Interactive comment on “Impacts of the emergency operation of the South-to-North Water Diversion Project’s eastern route on flooding and drainage in the water-receiving area: An empirical case from China” by Kun Wang et al.

Responses to Referee #2’ comments

Fig. 1.

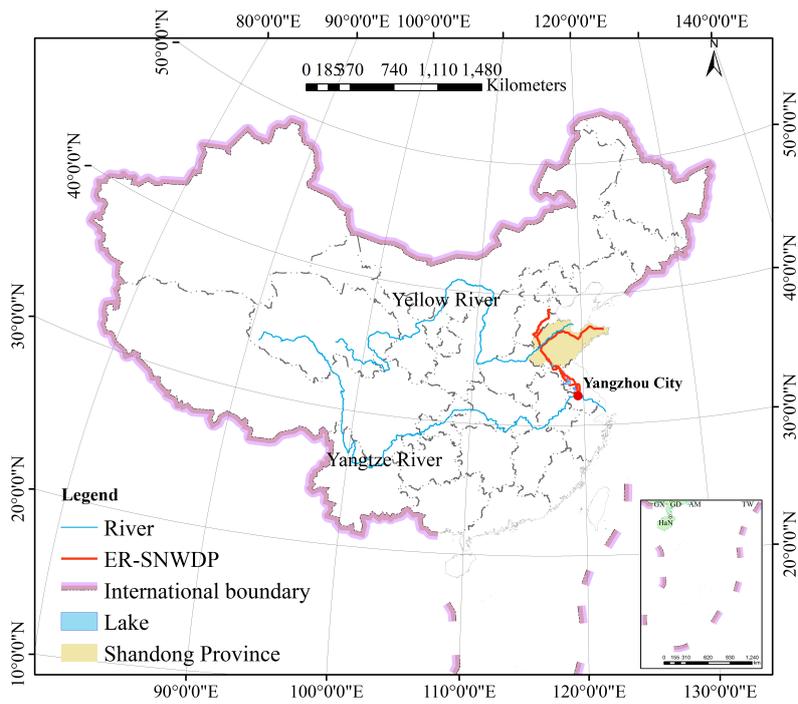
L28: a map showing the most important geographical places, including contour lines and information about elevations would be required. Furthermore, some climatic characterisations (annual rainfall as colourcode) would help understanding the general con-

Page 5 Fig. 1: Please add (a), (b) and (c) to the single figures, as it is usual. In the upper right map: why is China’s SE not continuously bordered? What does the inset map express and why is the international border southwards dashed? In the upper left map: please name the rivers. In the lower map: please indicate the location of the dam, Description of Fig. 5: delete “The logo of Copernicus publications” L4: what is Yangzhou? L5-8: please indicate the location of sluices and dams in Fig.1, otherwise it is impossible to follow.

Answer: Fig.1 has been divided to Fig.1 (in section1) and Fig.2 (in section 2).The contour lines of annual rainfall has been added in Fig.1 b, and Surface elevation information of Nansi Lake basin has been added in Fig.2.

Answer: Those figures have been modified as these suggestions. We made a map of China according to the convention of Chinese map. Thank you for your suggestions.

Fig. 2.

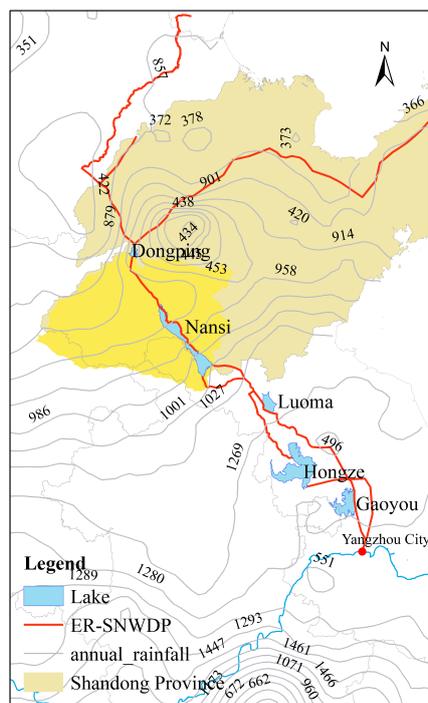
L29: development of what? L30: which lake and what does the lakeside area mean? It is somehow indicated in Fig. 1, but what are the borders, how are they defined, etc.

This is important to state. L15: again, the authors base on preliminary knowledge: it is not introduced, that the lake is separated into 2 halves by a dam. How can one know about the upper and the lower lake since the lake is just mentioned as the Nansi Lake.

L9: river channel bathymetry of which river? L11: please indicate the location of rainfall stations in map of Fig. 1. L13: please indicate the location of water level recording stations in Fig. 1

L10: The information concerning the locations of the stations is missing to follow argumentation

Answer: The economic development in lake basins along the ER-SNWDP. The lakeside area refers to the area with ground elevation below 36.79 m around Nansi Lake (Fig.2). We explained it in the manuscript, and Fig.2 is modified. Thanks a lot.

Answer: We explained perfected Fig.2 and cited it in introduction. Thanks a lot.

Answer: The channel bathymetry of all rivers simulated in the 1-D model. The location of rainfall stations have been added in Fig.2. Thanks a lot.

Answer: The locations of the stations have been added to Fig.2. Tanks a lot.

Fig. 3.

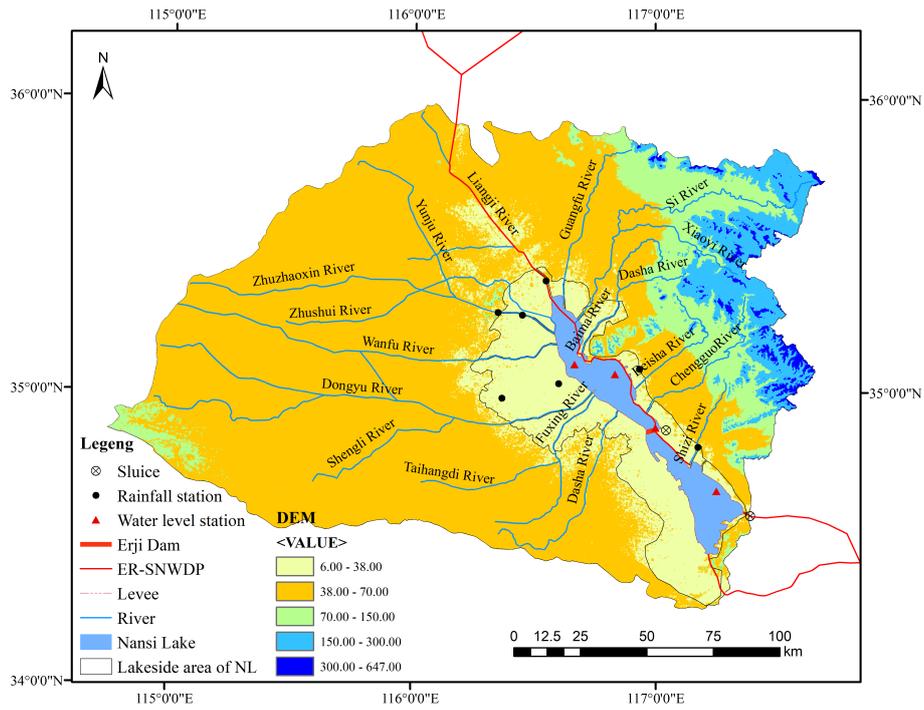
Page7 Fig. 2: where is MIKE FLOOD integrated into the workflow? L8-9: Equations are usually cited in the text.

Answer: The corresponding modification of Fig. 3 is made. And we revised the reference.
